CRUISER AIRCRAFT	<h1>SERVICE BULLETIN</h1>	Czech Aircraft Group s.r.o. Na Záhonech 212 686 04 Kunovice Czech Republic info@cruiseraircraft.com
		Rev.: 1
		Date: 2021-01-28
		No. SB-CR-033
Date: 2016-03-18		
Page: 1 of 10

MODEL AFFECTED:	PS-28 Cruiser SportCruiser / PiperSport - under EASA PtF operation only
SUBJECT:	Change from Cylinder Head Temperature to Coolant Temperature measurement method for aircraft equipped with Rotax 912 ULS and 912 S2 series engine with a new cylinder head design.
AIRCRAFT AFFECTED:	PS-28 Cruiser up to S/N C0556 including SportCruiser – all S/N PiperSport – all S/N
COMPLIANCE:	As per EASA AD 2015-0240 (for Rotax engines)

Figure 3 - Difference between old and new cylinder head design and temperature sensor position

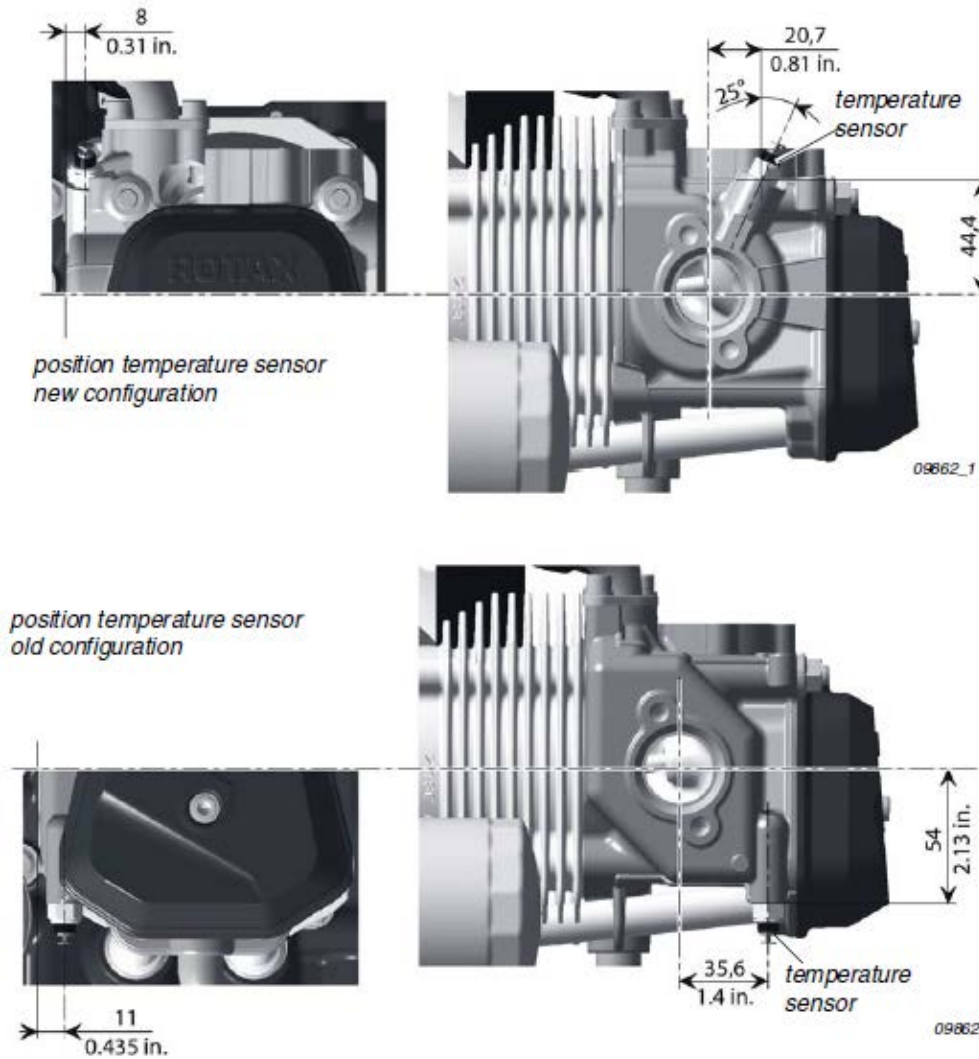
With the change to a new cylinder heads design (P/N 413185 at cylinder head position 2/3) no longer the Cylinder Head Temperature is measured, but the Coolant Temperature.

The measuring position of the temperature sensor has changed. With this new installation position of the temperature sensor, a loss of coolant can be recognized easily. The change to the new cylinder heads does not affect the cooling capacity.

- c) To recognize the **difference between the old and new cylinder head design and the temperature sensor position**, see Figure 3.

Figure 4 Check of the engine serial number S/N and the suffix -01 on the type plate. (see the whole SB-912-068 R1 from ROTAX for details)

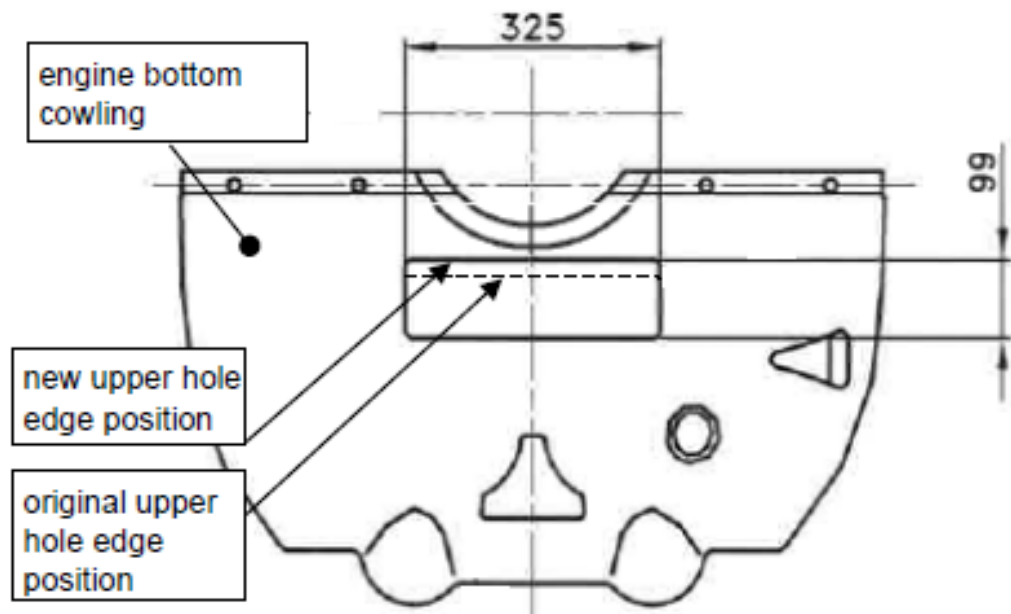
5. In case the **new cylinder heads design** (P/N 413185 at the cylinder head position 2/3) **is found**, check if the suffix-01 on the type plate is present, see Figure 4 below. If the suffix-01 on the type plate is not present, ensure a permanent application of the suffix -01 (e.g. engraved, stamped or similar), see Figure 4.
Note: In case there is only one cylinder head of the new type (P/N 413185) at a single position 2 or 3 installed, ensure at authorized service organization that the cylinder head of the old type on the other position (2 or 3, as applicable) be replaced with a new type of the cylinder head having P/N 413185.
Any changes regarding to this Service Bulletin must be confirmed in the logbook

Step	Procedure
1	Apply suffix - 01 permanently (e.g. engraved, stamped or similar) to the type plate. NOTE: Any changes regarding to this Service Bulletin must be confirmed in the engine logbook.
